Product Change Notification

Date Issued :	May 08, 2025	PCN Number :	516889
Reason for Change :	Product Design Change with Obsolescence		
Description of Change :	This notification is to inform you about changes that are being made to the part(s) as identified in the list.		
Reason for Short Notice :	Corrective Actions		
Assessment of Change :	Reliability Test Report/s		
Planned Implementation Date :	September 30, 2025		
Customer Sample Availability Date:	April 30, 2025		
Last date to request Samples by Customer :	May 31, 2025		
Please note if Samples are not requested as per Customer Samples Request date, it may take additional 4-6 weeks to arrange Samples.			
Recommended replacement parts :	Please see the attached replacement parts list .xls file.		
Last Time Buy Date for Obsolete Parts :	July 01, 2025		
Last Time Ship Date for Obsolete Parts :	August 30, 2025		
Traceability Code Markings / Date :	New part number

■ HFM cavity update on 10+1+1 and 10+2 male connectors

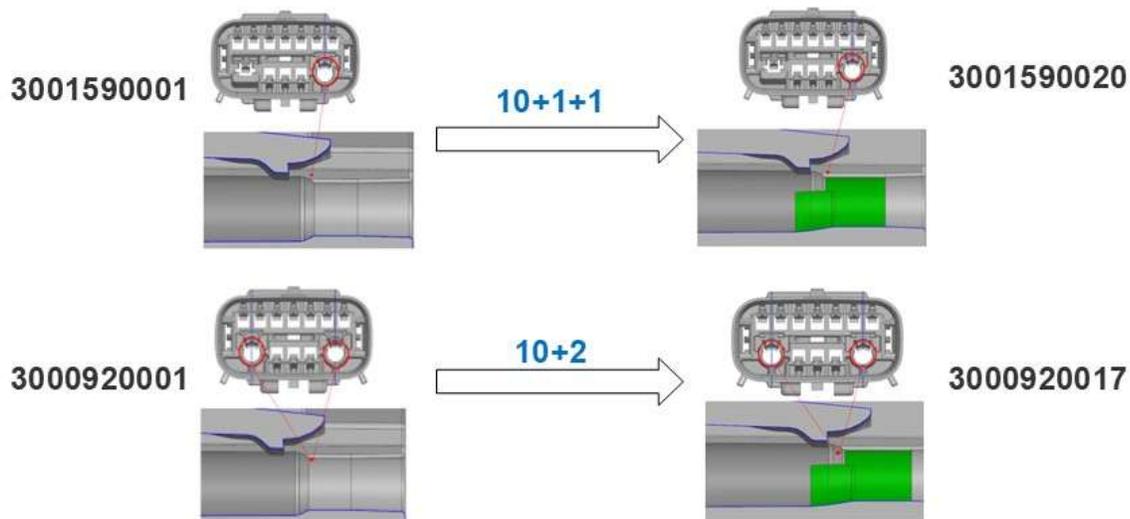
- HFM cavity updates on 10+1+1 and 10+2 male connectors. Changes needed to improve terminal forward stop performance during HFM assembly.

- Part number changes to male connectors (fit / form / function change)
- Part Number Impact: See attached impacted parts list
- Qualification reports and samples available upon request
